LASALLE COUNTY STATION, UNIT 1

AMENDMENT TO FACILITY OPERATING LICENSE

Amendment No. 71
License No. NPF-11

LASALLE COUNTY STATION, UNIT 2

Figure 3.4.6.1-1

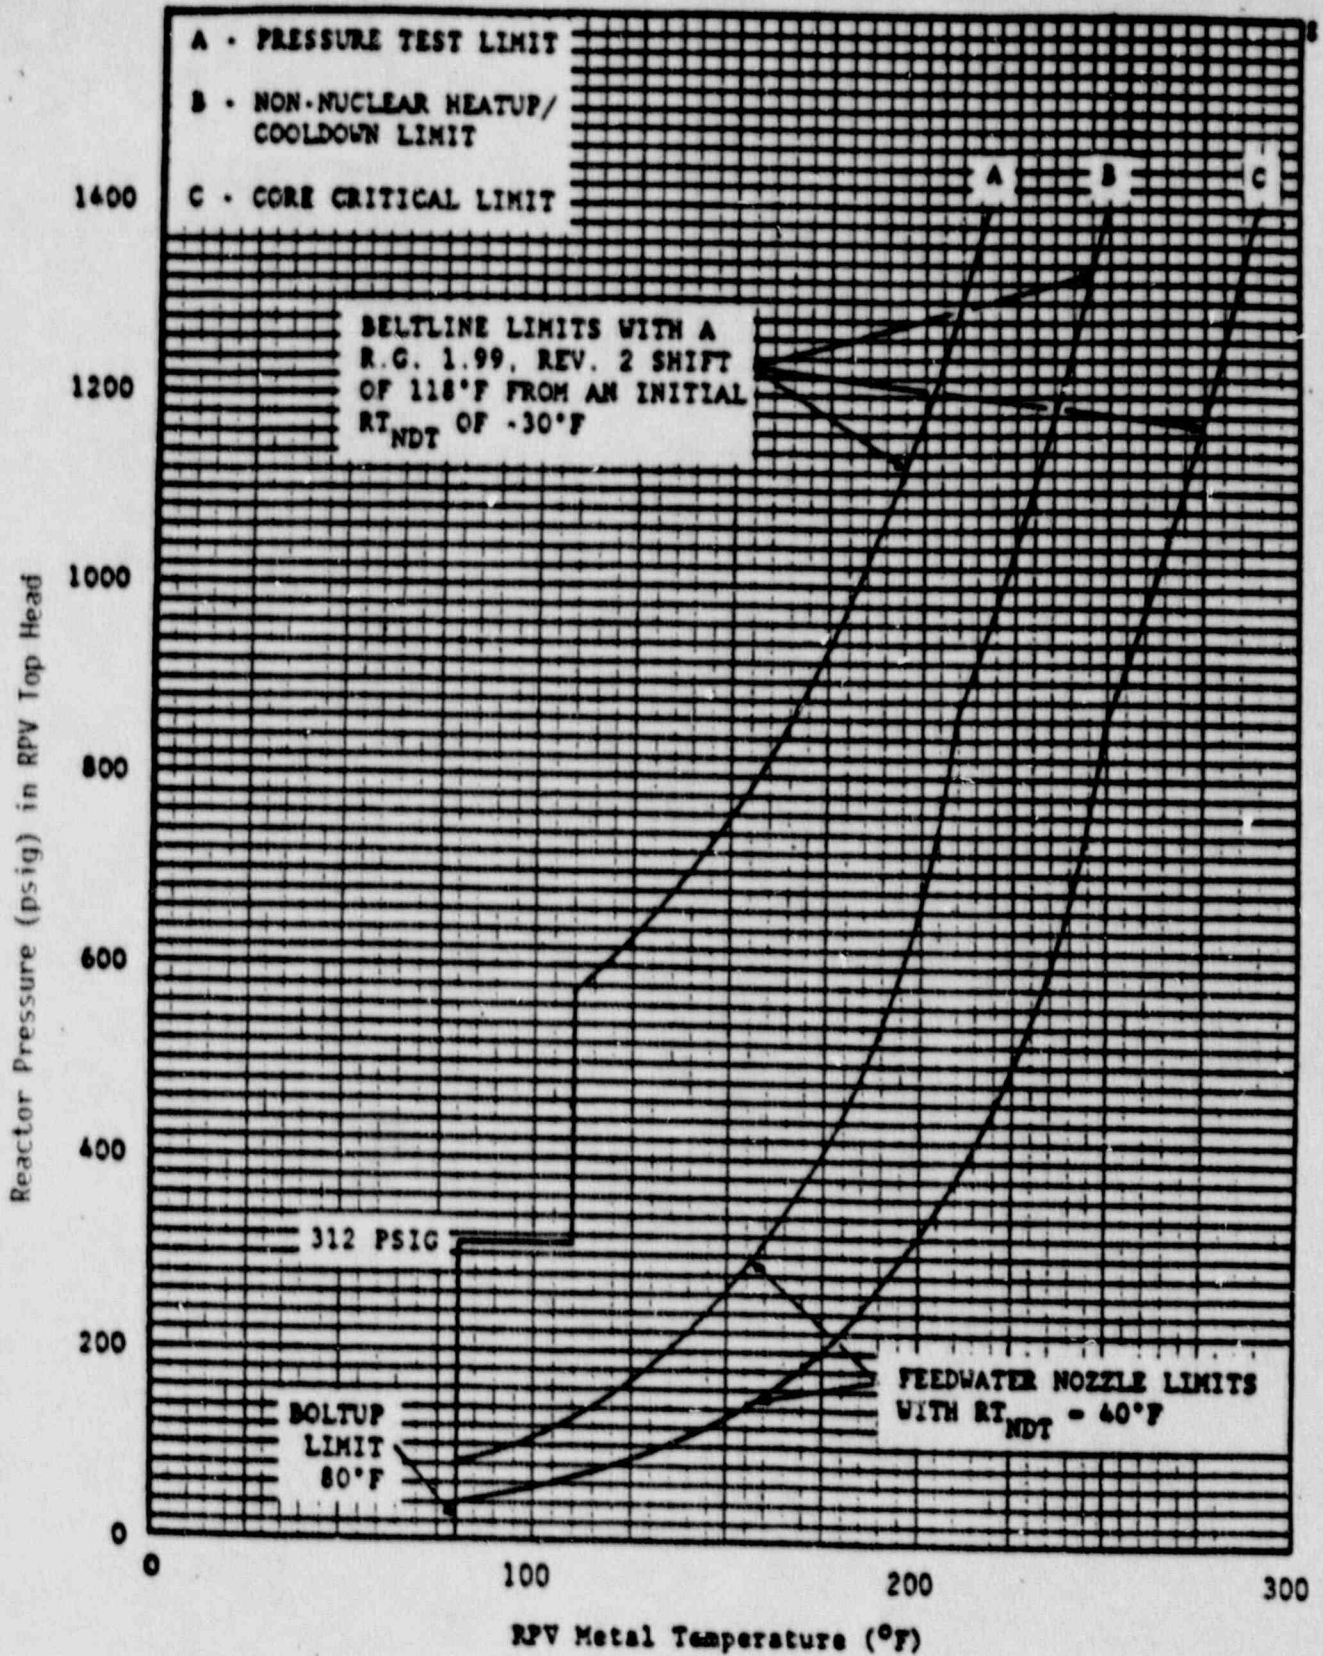
3.4.6.1 The reactor coolant system temperature and pressure shall be limited in accordance with the limit lines shown on Figures 3.4.6.1-1 and 3.4.6.1-1a (1) curves A for hydrostatic or leak testing; (2) curves B for heatup by non-nuclear means, cooldown following a nuclear shutdown and low power PHYSICS TESTS; and (3) curves C for operations with a critical core other than low power PHYSICS TESTS, with:

4.4.6.1.1 During system heatup, cooldown and inservice leak and hydrostatic testing operations, the reactor coolant system temperature and pressure shall be determined to be within the above required heatup and cooldown limits and to the right of the limit lines of Figures 3.4.6.1-1 and 3.4.6.1-1a curves A or B, as applicable, at least once per 30 minutes.

4.4.6.1.2 The reactor coolant system temperature and pressure shall be determined to be to the right of the criticality limit line of Figures 3.4.6.1-1 and 3.4.6.1-1a curves C within 15 minutes prior to the withdrawal of control rods to bring the reactor to criticality.

4.4.6.1.3 The reactor vessel material specimens shall be removed and examined to determine reactor pressure vessel fluence as a function of time and THERMAL POWER as required by 10 CFR Part 50, Appendix H in accordance with the schedule in Table 4.4.6.1.3-1. The results of these fluence determinations shall be used to update the curves of Figures 3.4.6.1-1 and 3.4.6.1-1a.

The reactor vessel materials have been tested to determine their initial RT_{NDT} . The results of these tests are shown in Table B 3/4.4.6-1. Reactor operation and resultant fast neutron, E greater than 1 Mev, irradiation will cause an increase in the RT_{NDT} . Therefore, an adjusted reference temperature, based upon the fluence, nickel content and copper content of the material in question, can be predicted using the recommendations of Regulatory Guide 1.99, Revision 2, "Effects of Residual Elements on Predicted Radiation Damage to Reactor Vessel Materials." The pressure/temperature limit curve, Figure 3.4.6.1-1, includes predicted adjustments for this shift in RT_{NDT} at the end of sixteen effective full power years (EFPY) while Figure 3.4.6.1-1a includes predicted adjustments in RT_{NDT} at the end of life fluence.

confidence in predicting reactor vessel material transition temperature shift. The operating limit curves of Figures 3.4.6.1-1 and 3.4.6.1-1a shall be adjusted, as required, on the basis of the specimen data and the recommendations of Regulatory Guide 1.99, Rev. 2.

The pressure-temperature limit lines shown in Figures 3.4.6.1-1 and 3.4.6.1-1a for reactor criticality and for inservice leak and hydrostatic testing have been established using the requirements of Appendix G to 10 CFR Part 50 for reactor criticality and for inservice leak and hydrostatic testing, General Electric "Transient Pressure Rise Affecting Fracture Toughness Requirement for Boiling Water Reactors," NEDO-21778-A, December 1978, and "Protection Against Non-Ductile Failure" of the ASME Boiler and Pressure Vessel Code, 1971 Edition, including Summer 1972 Addenda.

Figure 3.4.6.1-1

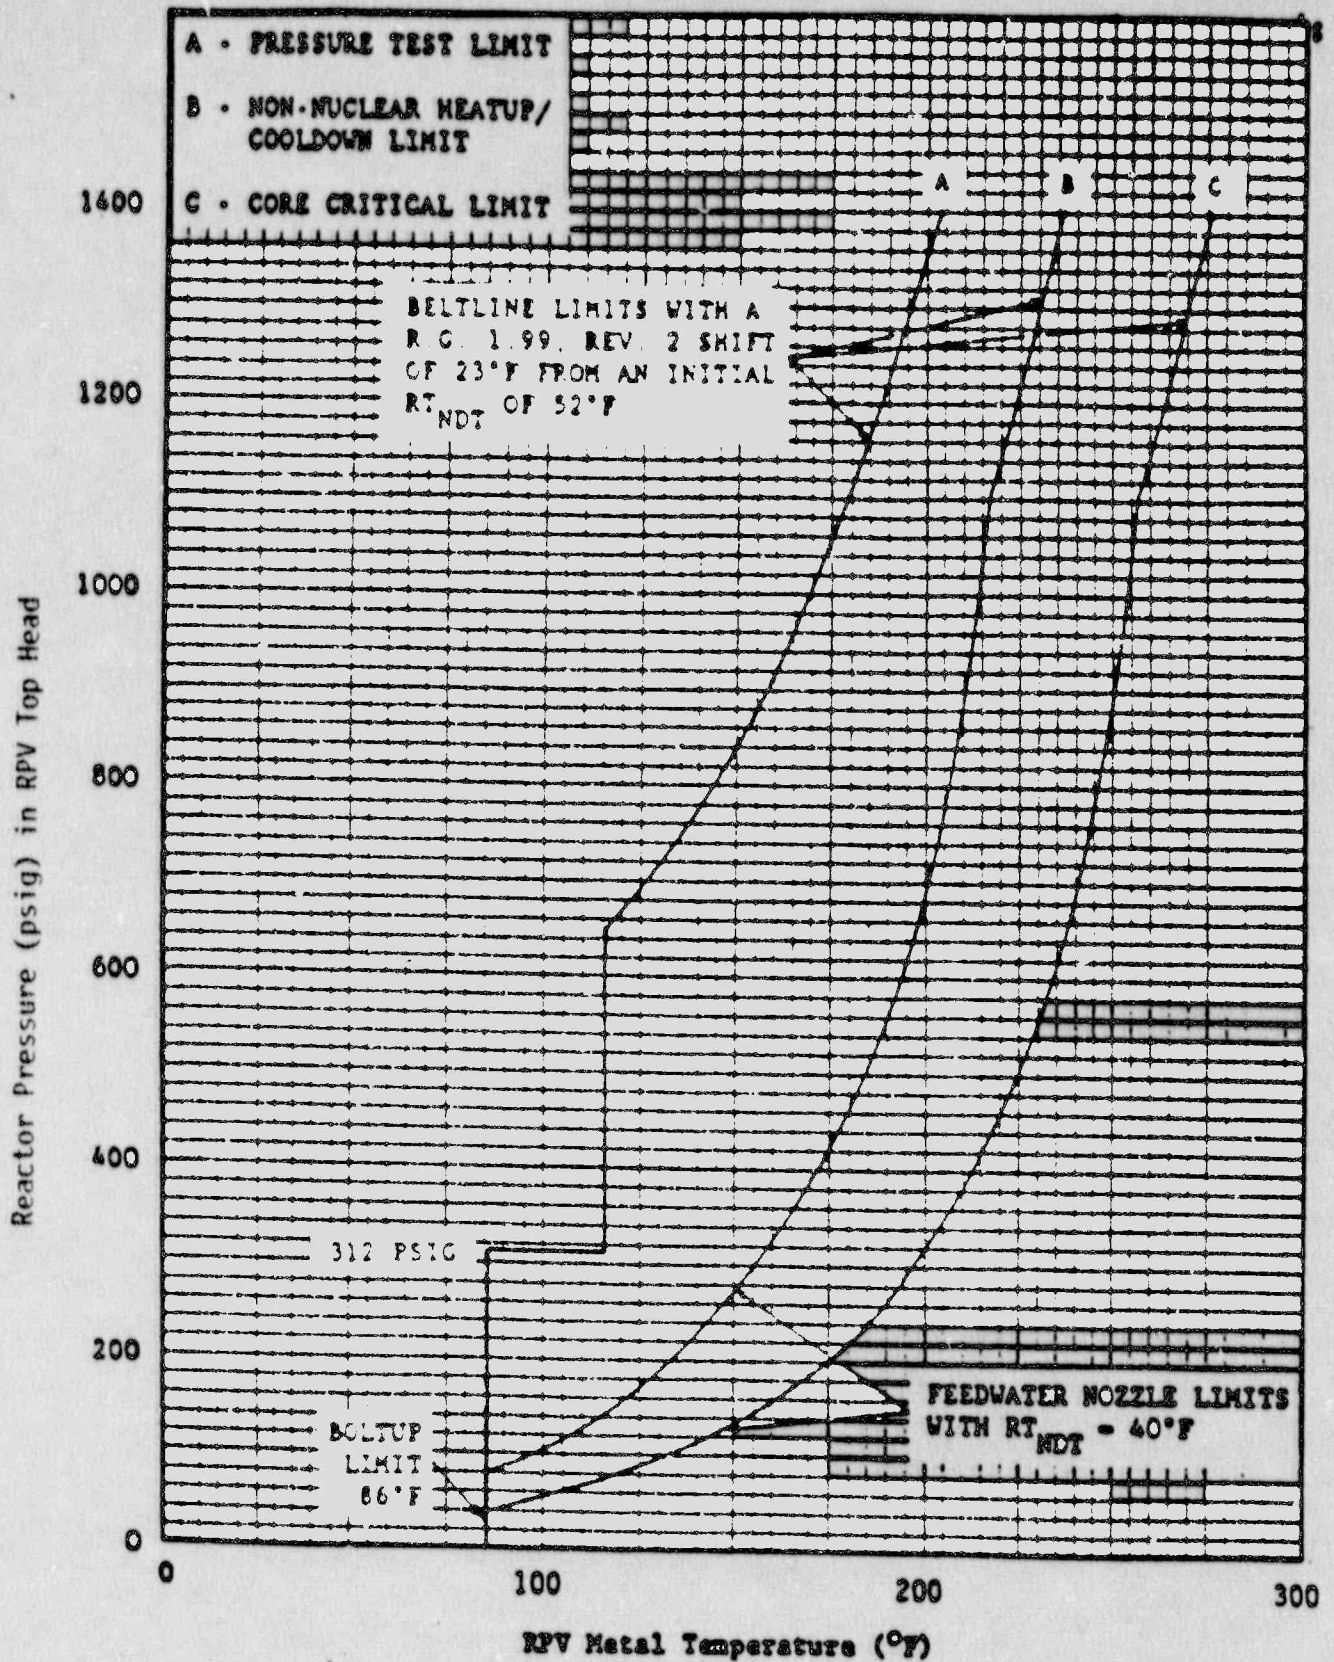
3.4.6.1 The reactor coolant system temperature and pressure shall be limited in accordance with the limit lines shown on Figures 3.4.6.1-1 and 3.4.6.1-1a; (1) curves A for hydrostatic or leak testing; (2) curves B for heatup by non-nuclear means, cooldown following a nuclear shutdown and low power PHYSICS TESTS; and (3) curves C for operations with a critical core other than low power PHYSICS TESTS, with:

4.4.6.1.1 During system heatup, cooldown and inservice leak and hydrostatic testing operations, the reactor coolant system temperature and pressure shall be determined to be within the above required heatup and cooldown limits and to the right of the limit lines of Figures 3.4.6.1-1 and 3.4.6.1-1a curves A or B, as applicable, at least once per 30 minutes.

4.4.6.1.2 The reactor coolant system temperature and pressure shall be determined to be to the right of the criticality limit line of Figures 3.4.6.1-1 and 3.4.6.1-1a curves C within 15 minutes prior to the withdrawal of control rods to bring the reactor to criticality.

4.4.6.1.3 The reactor vessel material specimens shall be removed and examined to determine reactor pressure vessel fluence as a function of time and THERMAL POWER as required by 10 CFR Part 50, Appendix H in accordance with the schedule in Table 4.4.6.1.3-1. The results of these fluence determinations shall be used to update the curves of Figures 3.4.6.1-1 and 3.4.6.1-1a.

The reactor vessel materials have been tested to determine their initial RT_{NDT} . The results of these tests are shown in Table B 3/4.4.6-1. Reactor operation and resultant fast neutron, E greater than 1 Mev, irradiation will cause an increase in the RT_{NDT} . Therefore, an adjusted reference temperature, based upon the fluence, nickel content and copper content of the material in question, can be predicted using the recommendations of Regulatory Guide 1.99, Revision 2, "Effects of Residual Elements on Predicted Radiation Damage to Reactor Vessel Materials." The pressure/temperature limit curve, Figure 3.4.6.1-1, includes predicted adjustments for this shift in RT_{NDT} at the end of sixteen effective full power years (EFPY) while Figure 3.4.6.1-1a includes predicted adjustments in RT_{NDT} at the end of life fluence.

confidence in predicting reactor vessel material transition temperature shift. The operating limit curves of Figures 3.4.6.1-1 and 3.4.6.1-1a shall be adjusted, as required, on the basis of the specimen data and the recommendations of Regulatory Guide 1.99, Rev. 2.

The pressure-temperature limit lines shown in Figures 3.4.6.1-1 and 3.4.6.1-1a for reactor criticality and for inservice leak and hydrostatic testing have been established using the requirements of Appendix G to 10 CFR Part 50 for reactor criticality and for inservice leak and hydrostatic testing, General Electric "Transient Pressure Rise Affecting Fracture Toughness Requirement for Boiling Water Reactors," NEDO-21778-A, December 1978, and "Protection Against Non-Ductile Failure" of the ASME Boiler and Pressure Vessel Code, 1971 Edition, including Summer 1972 Addenda.
